RESOLUTION

R6 - 2019

Certificates of Appropriateness for work in the Historic Districts: 224 N 9th Street and 1501 Linden Street

CITY OF ALLENTOWN HISTORIC ARCHITECTURAL REVIEW BOARD FINAL REVIEW SHEET January 10, 2018

Case #HDC-2018-00041- Proposal to continue installation of vinyl siding

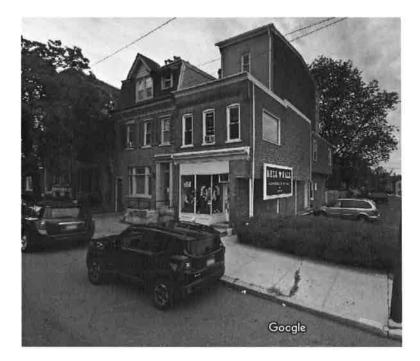
Building description, period, style, defining features: This structure is a 3 bay, 3 story, tan brick, semi-detached mixed-use building with flat roof, corbelled roof cornice, 1 over 1 double hung windows and first floor storefront with wood and metal projecting cornice. The building is altered with a 3rd floor brick and stucco addition set back from the front façade in the range of 15'. The building was also likely attached to another building that was removed leaving the former grocer alley open and second floor side wall exposed. The building dates from c.1897-1911 and is Italianate in style. The second-floor side wall of the building has been covered with asphalt (Insul-Brick) siding above the recessed grocer alley wall of red brick. The rear cantilevered portion of the building, formerly covered with the same Insul-Brick siding has been covered with white vinyl siding without HARB review.

Proposed alterations: It is proposed to continue installation of vinyl siding over insulating siding, commonly known as Insul-Brick, on the side of the building and to install vinyl siding along the remainder of the side of the building currently covered with similar insulating siding. **Staff Approvals:** N/A

Evaluation, effect on historic district, recommendations: Vinyl is not an appropriate material for thus highly visible side façade. Alternative historically appropriate options are smooth, fiber cement siding, such as HardiPlank or smooth cement-based stucco since the building is a masonry structure and there is stucco at the rooftop addition. Existing trim should not be covered with new siding as done with the vinyl siding installation.

Discussion: The applicant explained he was having problems with squirrels and drafts in the building and needed to close in the walls better. Mr. Huber countered that vinyl siding would not keep the squirrels out of the building. The HARB reviewed the options he had for replacing the vinyl siding and the need to keep the window trim visible. The applicant decided fiber cement siding would be the best for him to install and colors recommended by the HARB. The use of PVC composite casing material was suggested to the applicant.

- 1. The proposal to continue installation of vinyl siding at 224 N 9th Street was presented by Gus Giapoutzis.
- 2. The white vinyl siding installed without approval will be removed.

- 3. Fiber cement siding in a tan or grayish color will be installed on both the side towards the front and the cantilevered section towards the rear.
- 4. Existing window trim will not be covered with siding.

- 5. Window trim and sills may be retained and repaired or replaced with white Azek or similar composite material matching existing trim and sills in size.

- 6. The brick on the north and south facades of the 3rd floor will be re-pointed. Preservation Brief #2 "Repointing Mortar Joints in Historic Masonry Buildings" guidance will be followed, and a soft lime-based mortar used.

- 7. The parging on the 3rd floor will be repaired in-kind and coated with elastomeric "paint" matching the new siding in color in a satin or matt finish.

- 8. Removal of the vinyl siding and installation of fiber cement siding with trim must be completed by May 15, 2019.
- 9. New lighting must be reviewed and approved by staff.

Case #HDC-2018-00042- Proposal to continue installation of the vinyl composite porch flooring

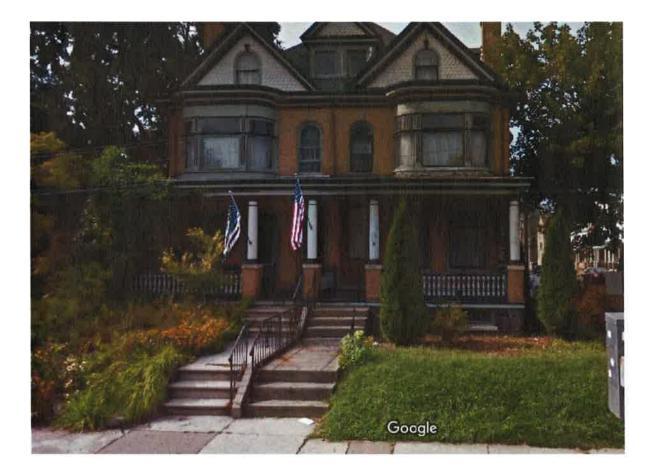
Proposed alterations: It is proposed to continue the installation of the vinyl composite porch flooring.

Evaluation, effect on historic district, recommendations: The installed flooring isn't technically appropriate according to guidelines, which stress the replacement of historic materials be in-kind. A tongue and groove wood floor should have been installed, and properly stained and sealed, which should hold up to weather over time if maintained. Understanding that maintenance tends to be neglected, the Trex product reduces maintenance requirements, and in this case, appears to closely resemble a stained wood floor. Samples should have been

provided, and in the future, this alternative material could be considered on a case by case basis. The other mitigating factor in this case is the elevated level of the porch which makes the porch floor surface hard to see from street level. The edge is the most visible and resembles the historic appearance.

The repair and painting of the railing and balusters is appropriately as completed. It is not clear if the soffit work was completed. In-kind replacement or repair of soffit elements is recommended.

Discussion: There was a thorough discussion of the porch floor. The applicant explained the problem he had with the deteriorated wood decking and the amount of windblown rain that impacts the porch because it is on a corner. He also said the porch floor was leaking and water was getting into the basement. A sample of the installed product was circulated. Mr. Huber said he had a problem with the dimensions of the product, the curved surface, and the edge detail. The applicant said he had put a cut board along the ends of the decking. Mr. Huber explained that the cut ends of boards are historically visible.

Ms. Jackson said she did not support allowing the decking installed to remain because it would be setting a poor precedent for a front façade. The other instances that the HARB approved a similar Trex-type product were all on rear facades and not highly visible. Other members of HARB agreed. Ms. Jackson went on to suggest a composite product that she could support. She said it was historically dimensioned and tongue and groove style. The manufacturer she was familiar with was "Aeratis". Details of the product were discussed and the HARB agreed it would be historically appropriate.

- 1. The proposal to continue the installation of the vinyl composite porch flooring at 1501 W Linden Street was presented by Henri Desrosiers.
- 2. The vinyl composite (Trex) porch flooring installed without HARB review and approval must be removed. The material does not have appropriate dimensions or edge treatment and is installed on the very visible primary/front façade of the building.
- The porch flooring will be replaced with historically appropriate fir, tongue and groove 2 ½" 3" wood decking or solid PVC composite (Aeratis or equal) tongue and grove 3" decking with factory finish or painted.
- 4. The porch floor replacement must be completed by May 15, 2019.
- 5. The existing concrete side steps will be retained and repaired in-kind. The concrete steps must keep the bullnose feature to match the original.
